**TOWN OF NEWBURGH
PLANNING BOARD**

PROJECT NAME: UNITY PLACE WAREHOUSE
PROJECT NO.: 21-29
PROJECT LOCATION: NORTHWEST CORNER OF OLD LITTLE BRITAIN RD. & UNITY WAY
SECTION 95, BLOCK 2, LOT 14.1 & 19.12
REVIEW DATE: 11 NOVEMBER 2022
MEETING DATE: 17 NOVEMBER 2022
PROJECT REPRESENTATIVE: BROOKER ENGINEERING

Re: **Unity Place Warehouse**

Patrick J. Hines, MHE Engineering, Technical Review Comments of 10/3/22

DATE: 05/27/2022
DRAWING NO: 3

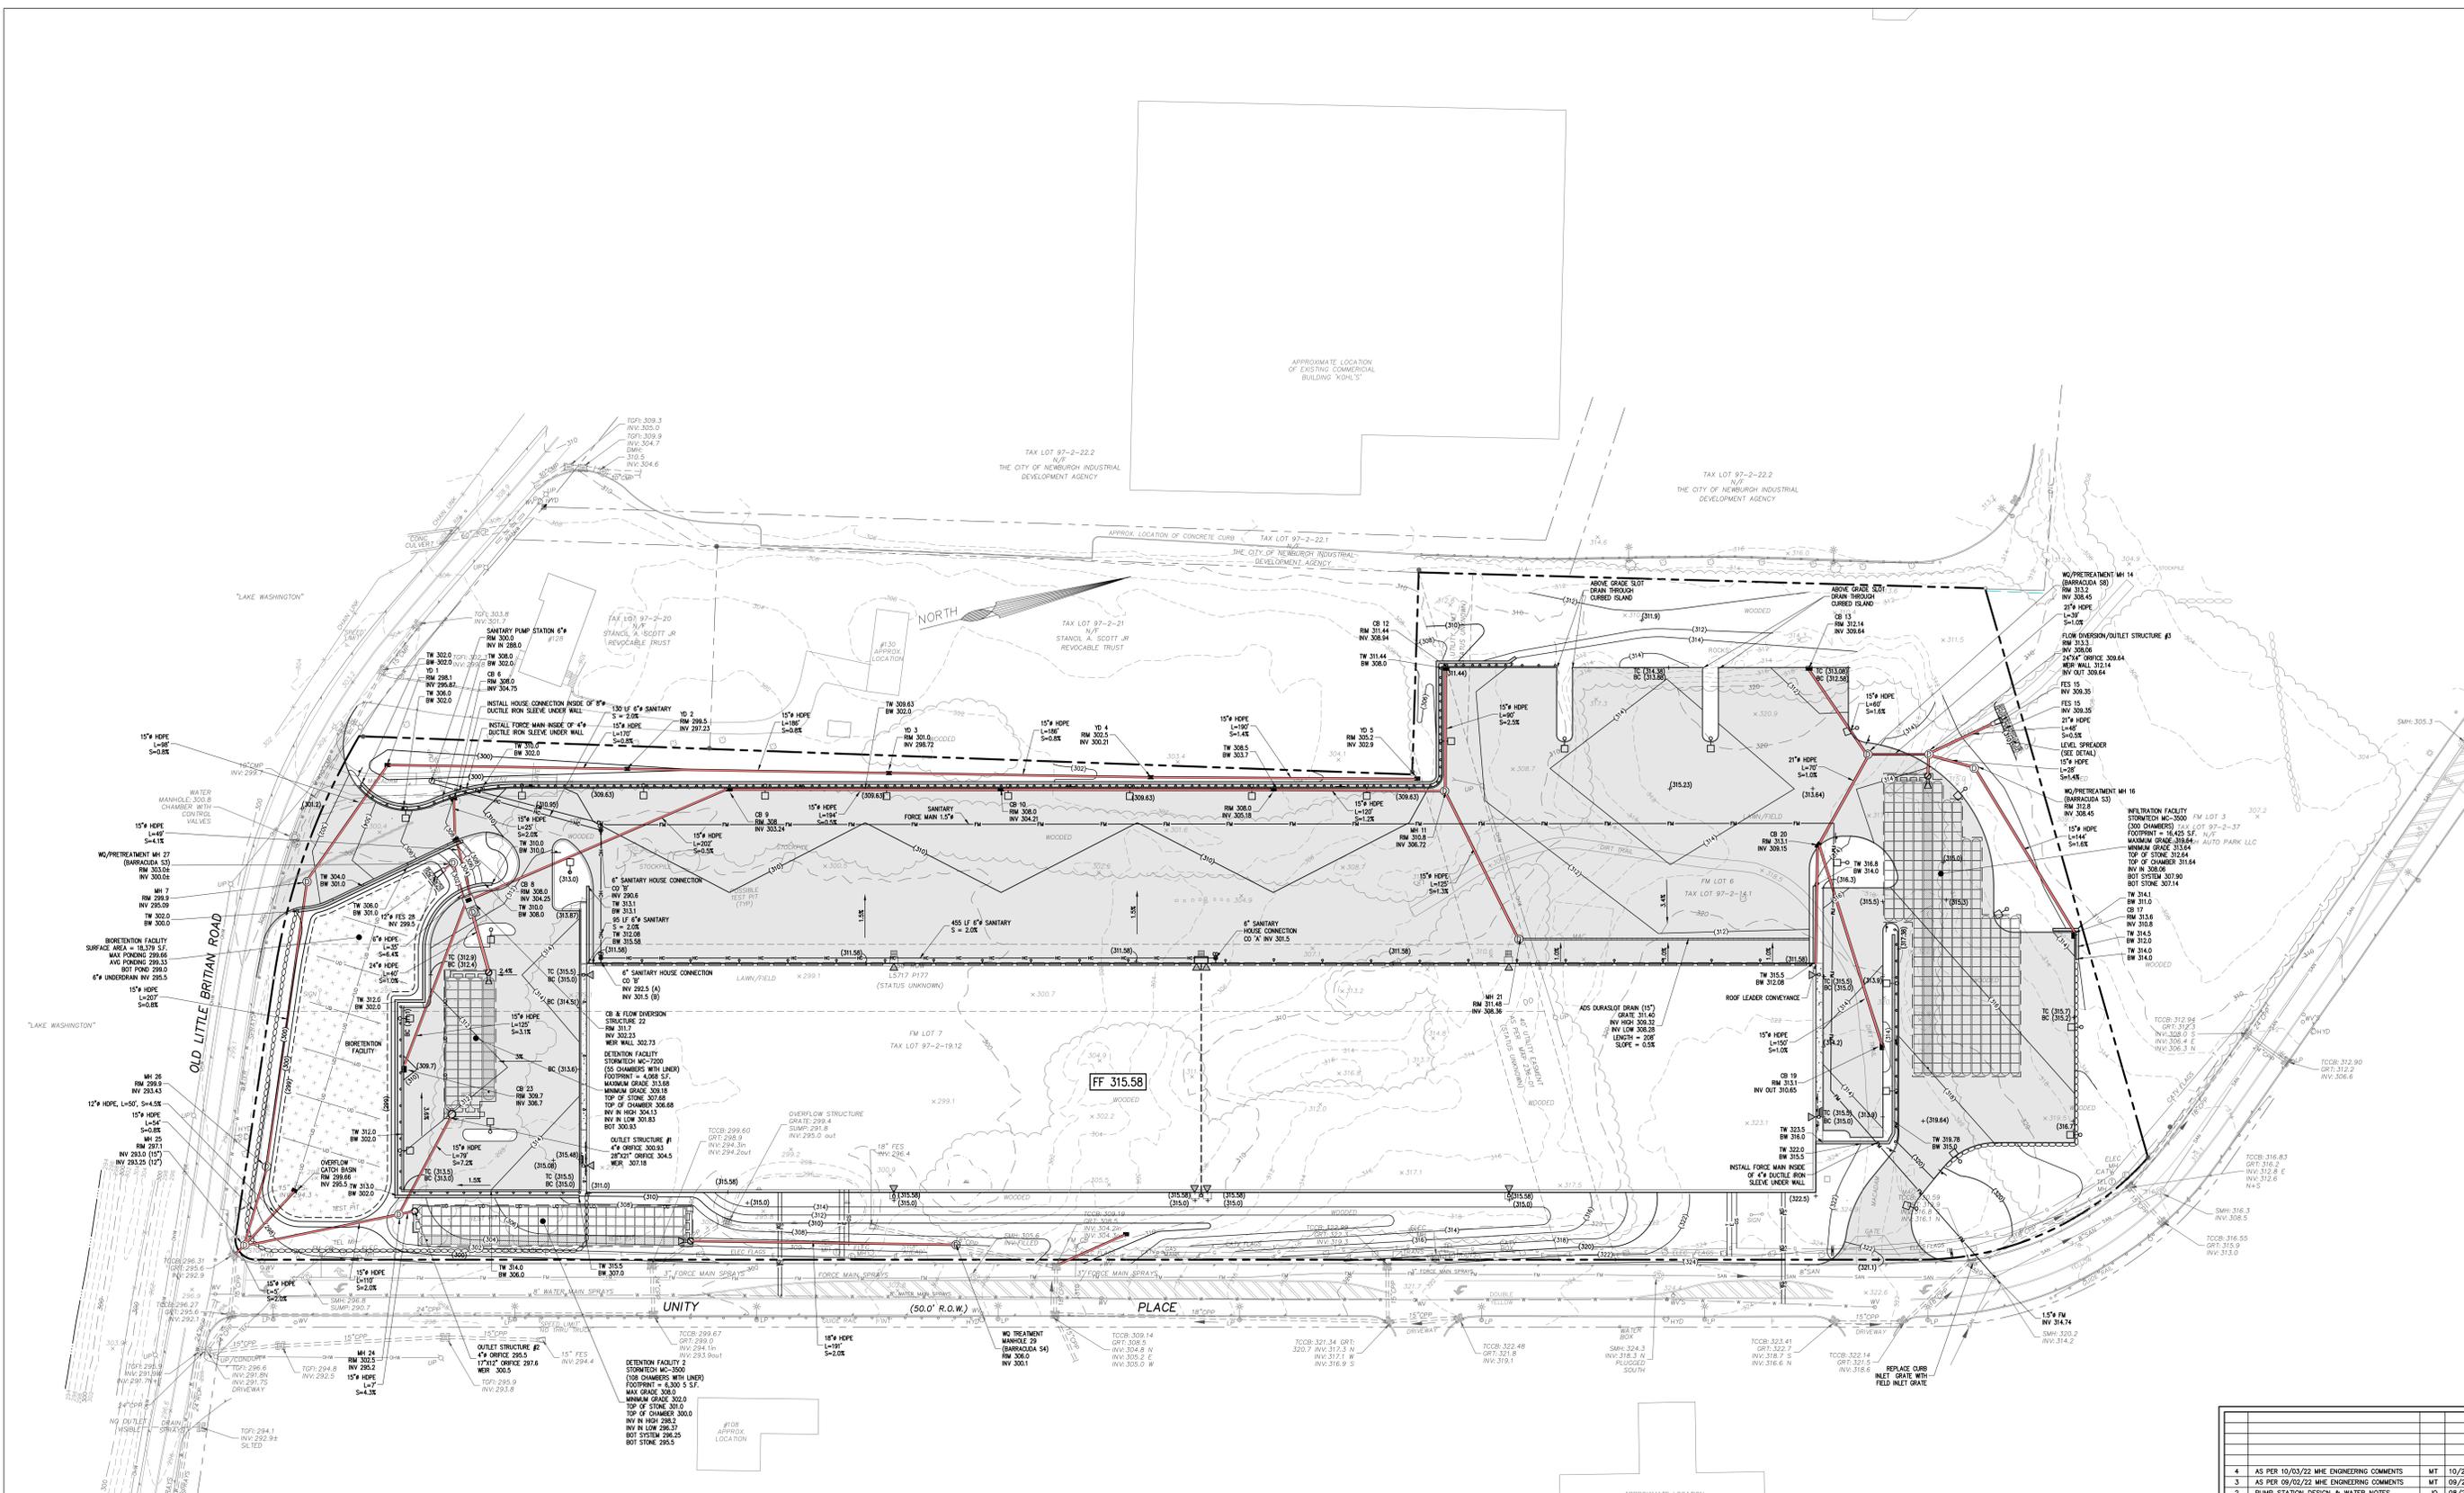
11. The applicant's representative are requested to advise whether the sanitary sewer pump station will be connected to an emergency power generator or if 24 hours of storage is provided in the wet well.
12. The Town of Newburgh water system notes are located on Drawing #3. Sewer notes must be added to the Plan. Manhole connection detail should be provided.
13. The Town of Newburgh requires water piping to be restrained using restraint joint pipe. A restraint joint pipe chart should be added to the water details.
14. The Highway Superintendent's comments regarding the access drives are outstanding.

PROJECT NO:	21202	DRAWN:	JO	CHECKED:	DR
SCALE:	1" = 40'				
GRAPHIC SCALE:	0' 40' 80'				
DATE:	05/27/2022	DRAWING NO.:	4

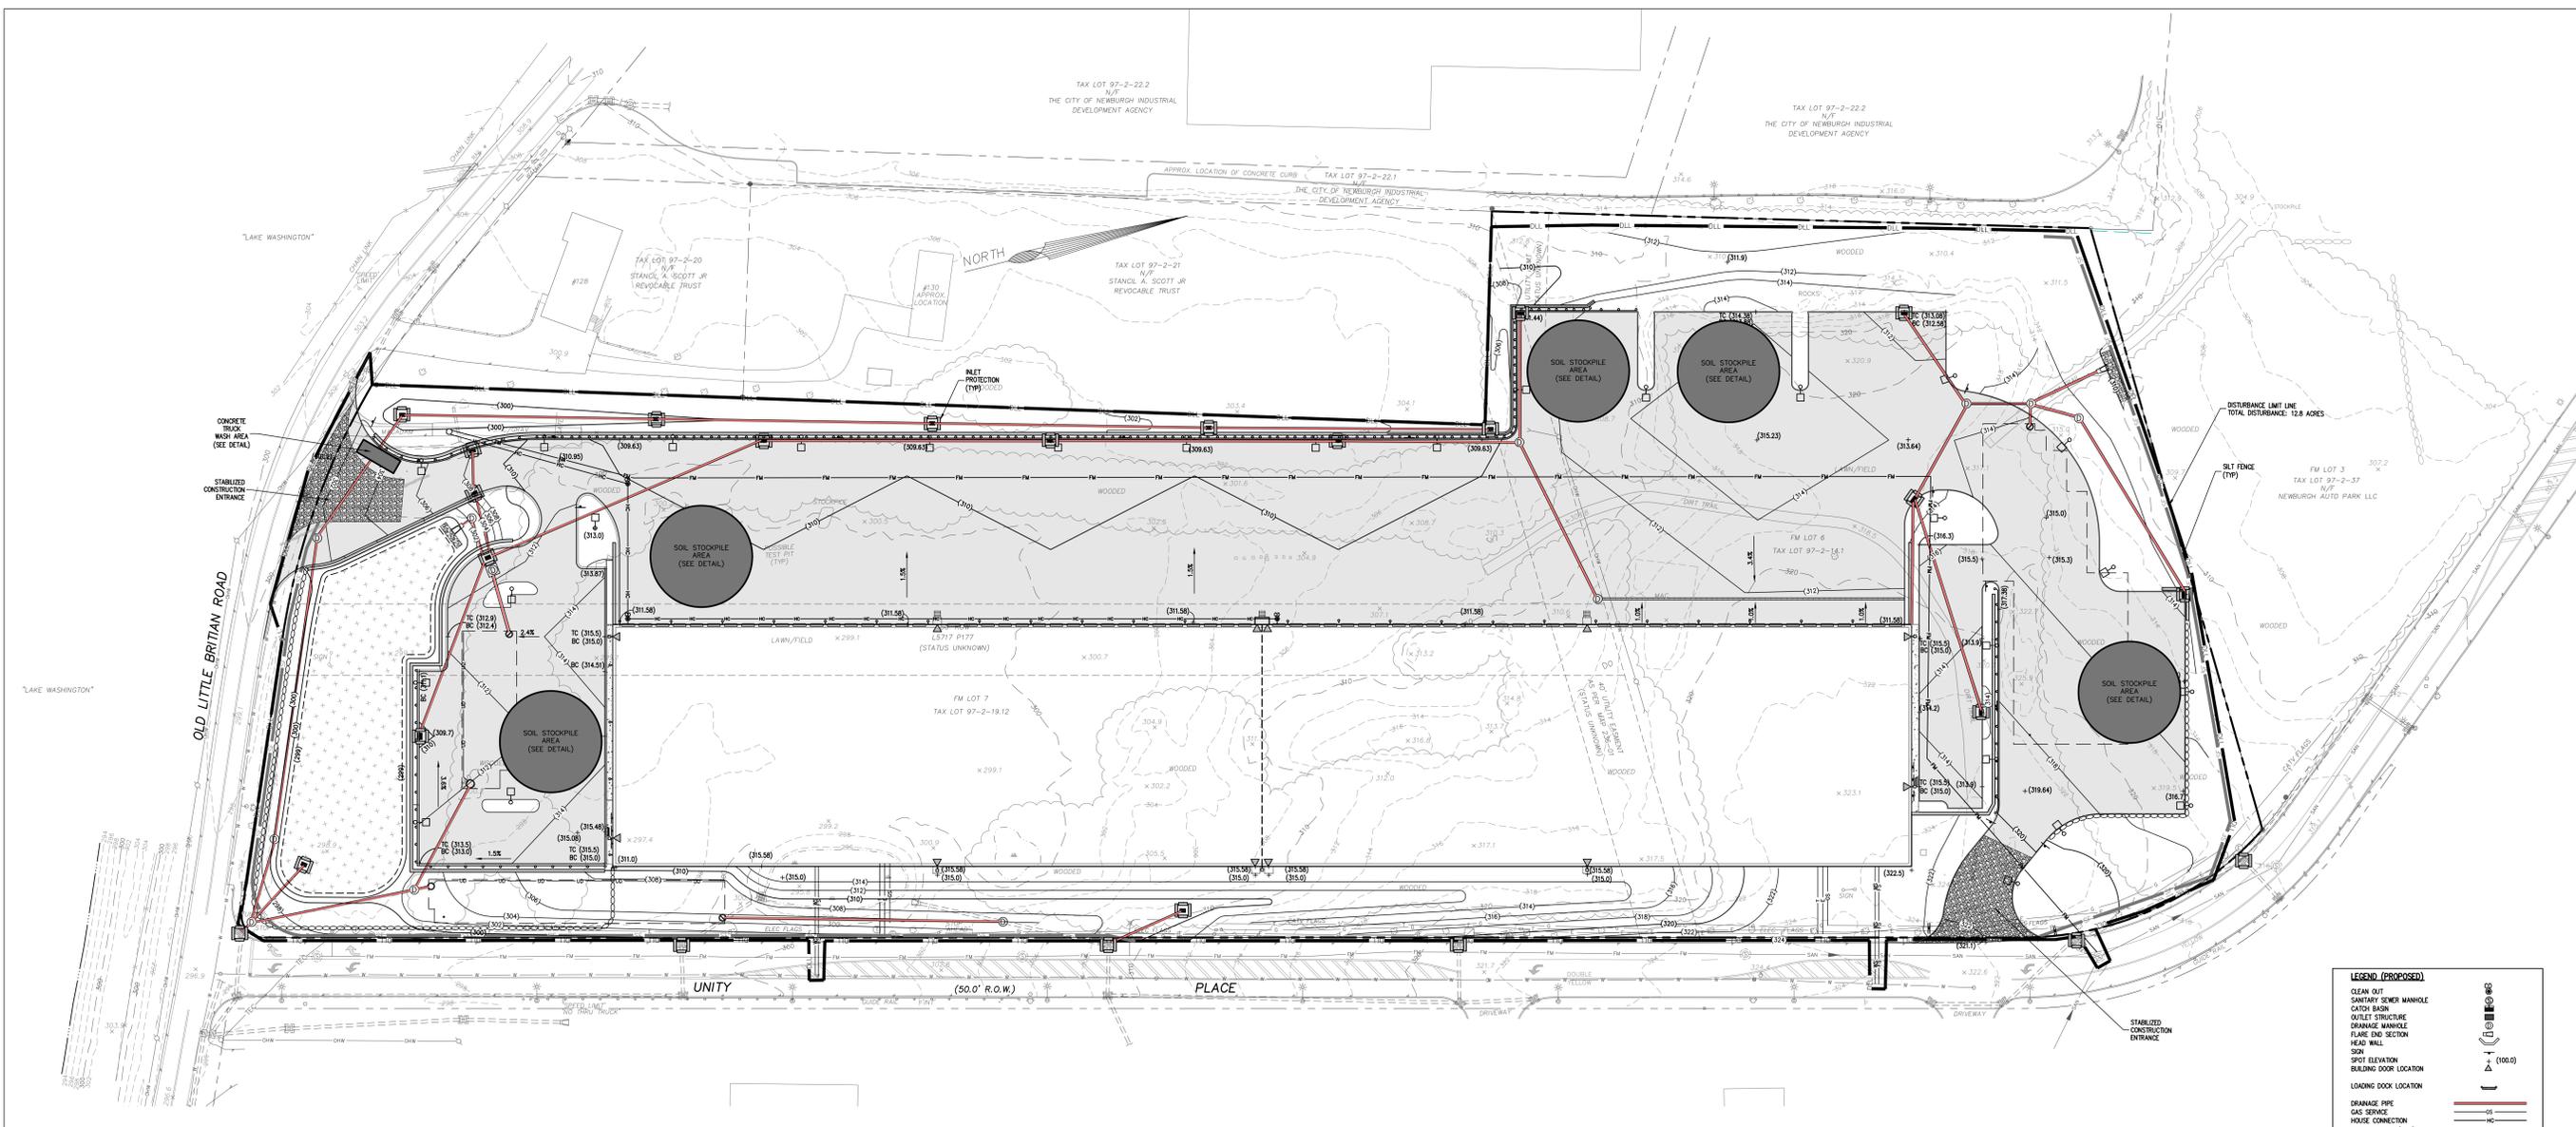
1. *COMMENT: The proposed construction sequence should be revised to include a pre-construction meeting with the Town's engineer, the Town representative, and the contractor to resolve any outstanding questions prior to the start of construction.*

Response: A pre-construction meeting was inserted as step #1 for the construction sequence as observed on Sheet 5 of the site plan and section 2.3 of the SWPPP.

1. PRE-CONSTRUCTION MEETING SHALL BE ORGANIZED WITH THE TOWN'S ENGINEER, TOWN REPRESENTATIVE, AND THE CONTRACTOR TO RESOLVE ANY OUTSTANDING QUESTIONS PRIOR TO THE START OF CONSTRUCTION.
